ASSESSMENT REPORT

Camden Gas Project – Kay Park Section 96(1A) Modification

On 21 October 2008, AGL lodged an application with the Department to modify the development consent for Kay Park under Section 96(1A) of the *Environmental Planning and Assessment Act 1979* (EP&A Act).

Figure 1: Location of Kay Park showing KP06 well

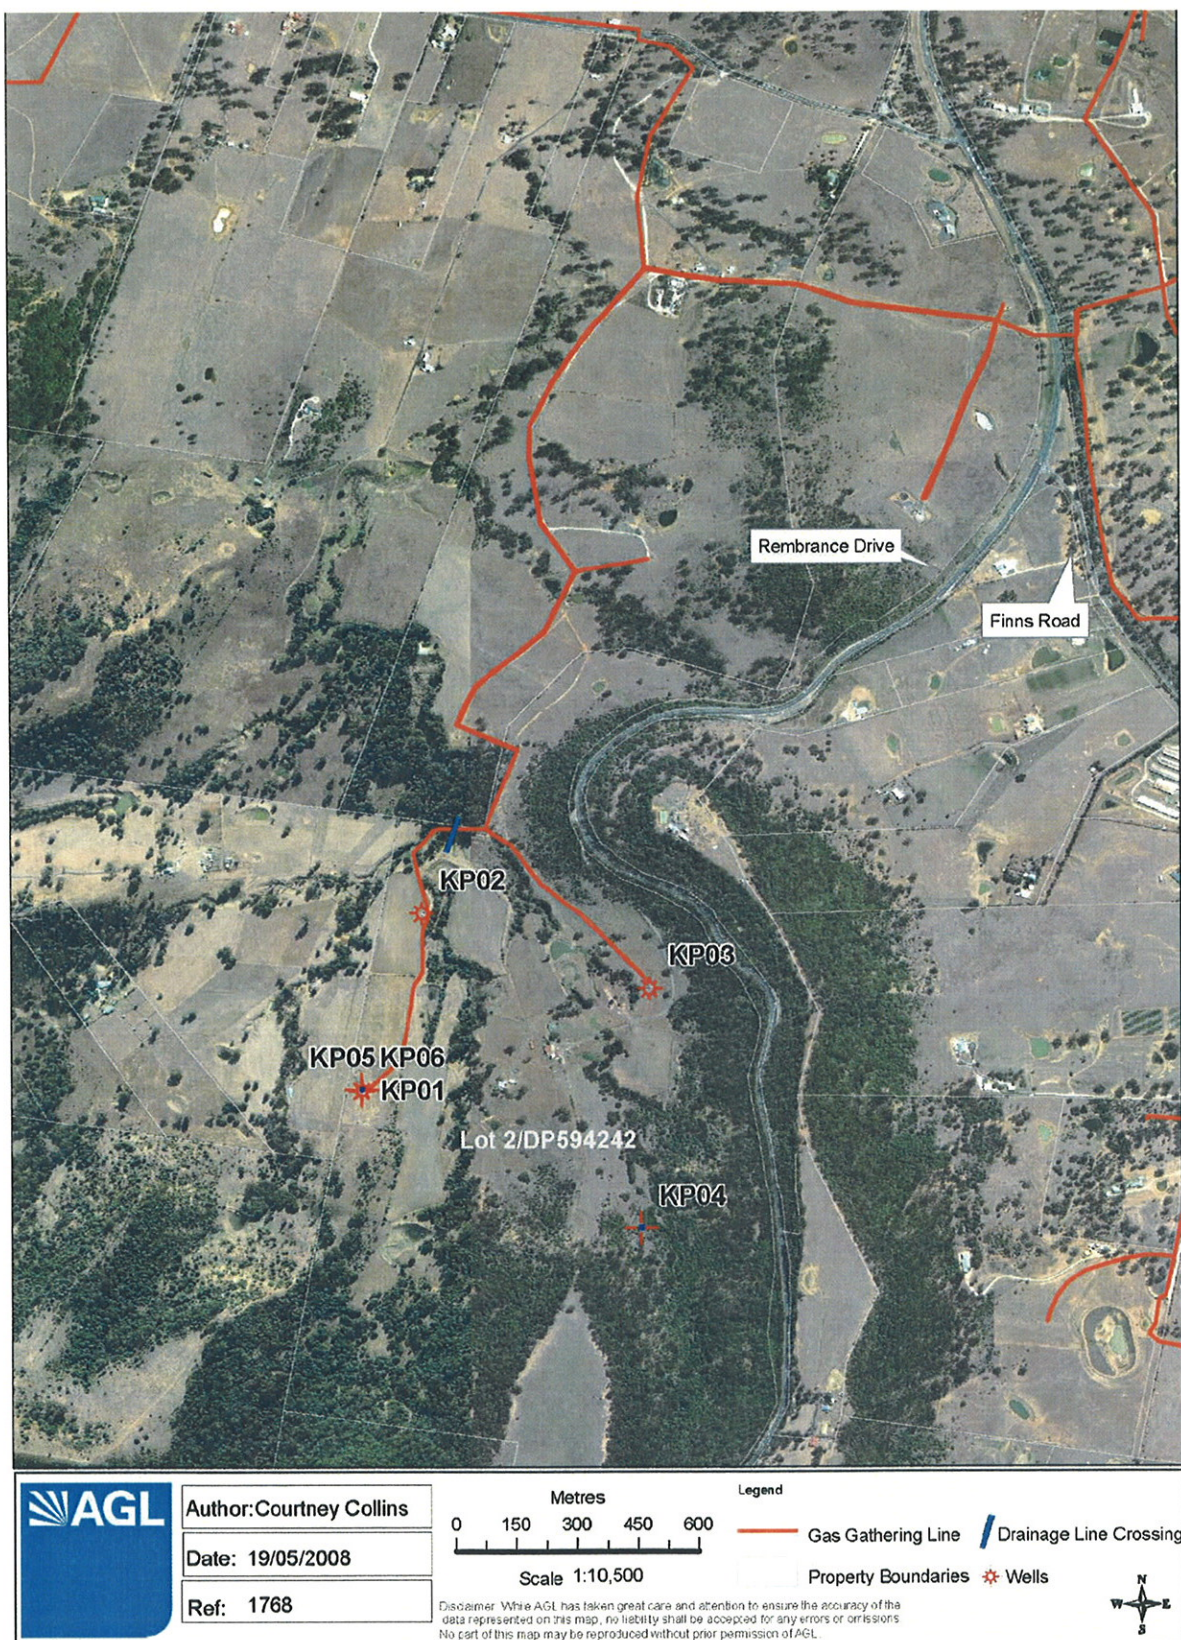
The proposed modification involves changing KP06 well from an approved but not yet constructed SIS well to a directional well.

constrained for SIS well construction. More importantly, directional wells significantly reduce the duration of drilling; in this case from 4 weeks to up to 1 week.
